Errata Sheet V1.5 affecting products TC26x_BB

N° 164/17

Subject: Errata Sheet V1.5 affecting products TC26x_BB.

Device TC26x
Marking/Step (E)ES-BB, BB
Package see Data Sheet

Figure 2 Message buffer transfer from Message RAM to OBF

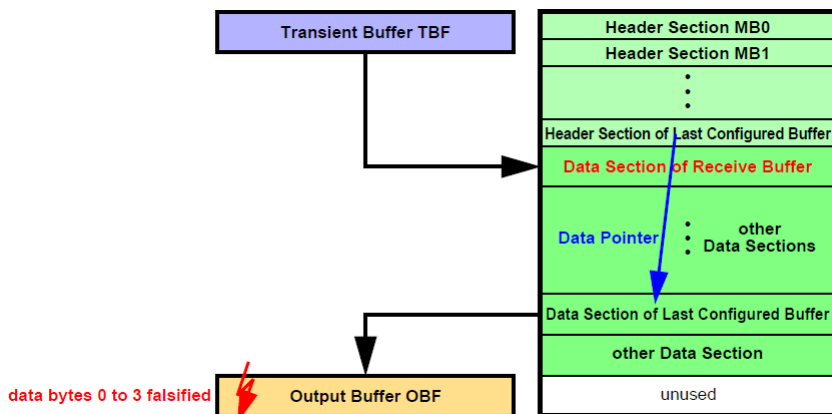
When the message buffer has its payload configured to maximum length (**PLC = 127**), the OBF word on address 00h (payload data bytes 0 to 3) is overwritten with unexpected data at the end of the transfer.

a) When a message is transferred from the Last Configured Buffer in the Message RAM to the OBF and **PLC** = 127 it may happen, that at the end of the transfer the OBF word on address 00h (payload data bytes 0 to 3) is overwritten with unexpected data (see [Figure 2](#)).

Figure 3 Message buffer transfer from IBF to Message RAM

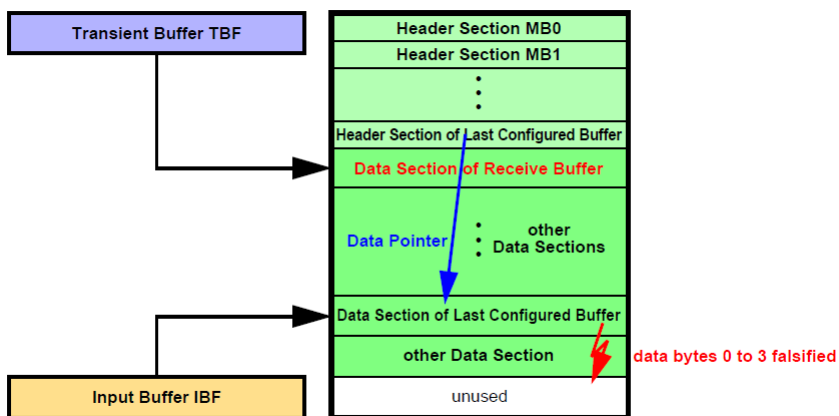
After the Data Section of the selected message buffer in the Message RAM has been written, one additional write access overwrites the following word in the Message RAM which might be the first word of the next Data Section.

b) When a message is transferred from IBF to the Last Configured Buffer in the Message RAM, it may happen, that at the end of the transfer of the Data Section one additional write access overwrites the following word, which may be the first word of another message's Data Section in the Message RAM (see [Figure 3](#)).

Figure 4 Message RAM Configurations

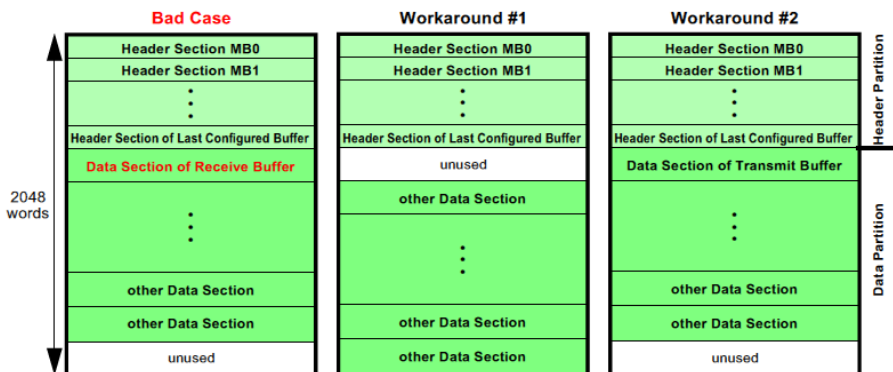
The erratum is limited to the case when (see [Figure 4](#) “Bad Case”):

2) Ensure that the Data Section directly following the Header Partition is assigned to a transmit buffer.

Figure 7 Recommended Software Handling - Flowchart

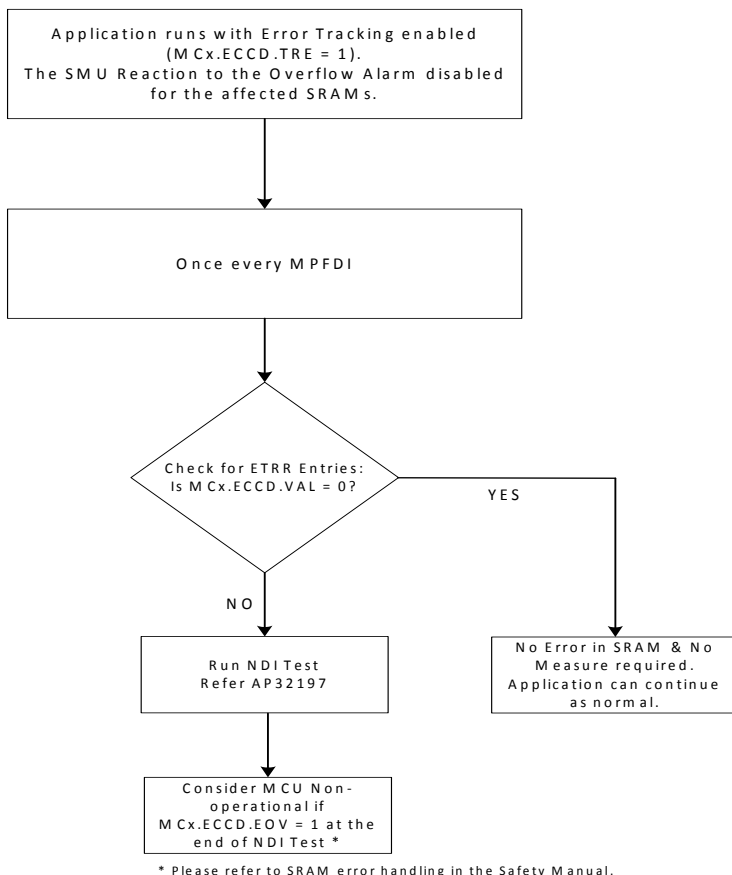
A flowchart of the recommended software handling is shown in [Figure 7](#).

If there is at least one valid ETRR entry (i.e. $MCx.ECCD.VAL \neq 0$) then the software shall run a Non-Destructive-Inversion (NDI) Test on the affected SRAM. Please refer to application note AP32197 (AURIX™ Memory tests using the MTU) for an example regarding running this test.

At the end of this test, if an ETRR overflow is detected ($MCx.ECCD.EOV = 1_B$) then the MCU shall be considered non-operational. Refer to section on Correctable SRAM Error handling in the Safety Manual.

Figure 9 EVR Supply Voltage VEXT Ramp-up - Critical Range

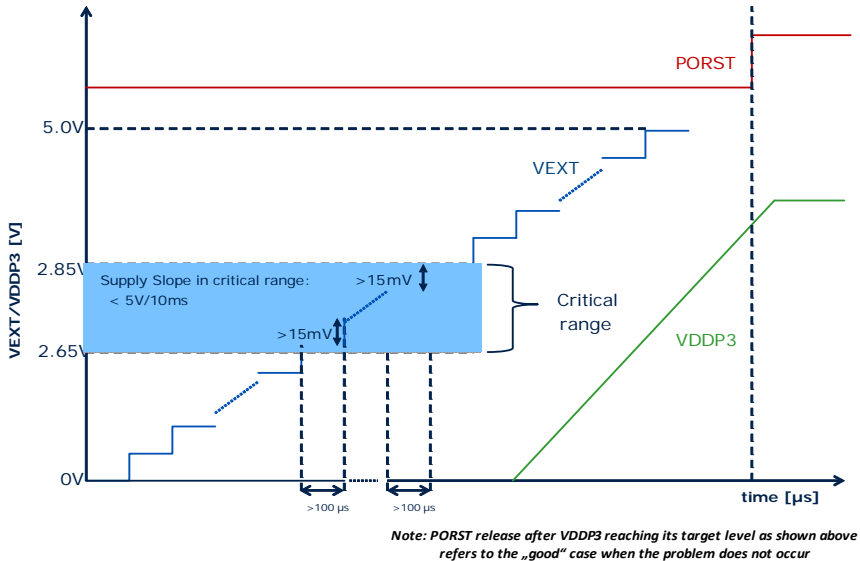
The device may not start in case of specific “non-monotonous” EVR supply voltage (V_{EXT}) ramp-up scenarios slower than 5V/10ms if the internal EVR33 voltage regulator is used. Characteristics of these scenarios are (one or more) plateaus of > 100 μ s in the range of 2.65 V < V_{EXT} < 2.85 V at the V_{EXT} pins (see [Figure 9](#)).

Workaround

- The startup issue is seen to happen only when there is at least one stationary non-monotonous step plateau greater than 100 µs (without buffer capacitors), with leading/trailing steps of >15 mV amplitude each, in the critical range as shown in [Figure 9](#).
- The fail behavior is observed mainly at cold temperatures up to room temperature.
- This issue is not confirmed by any observation in field.

Figure 17 Short Serial Message, Serial Data Encoding over 16 messages

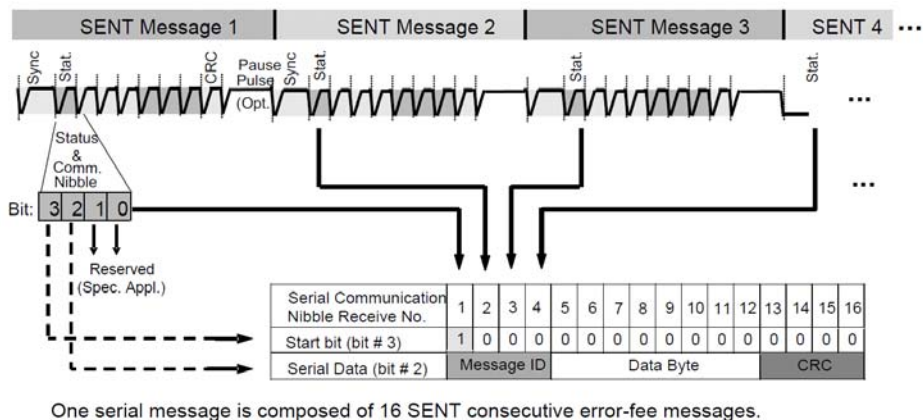
Correction

Figure 17 shows a corrected version of this figure.
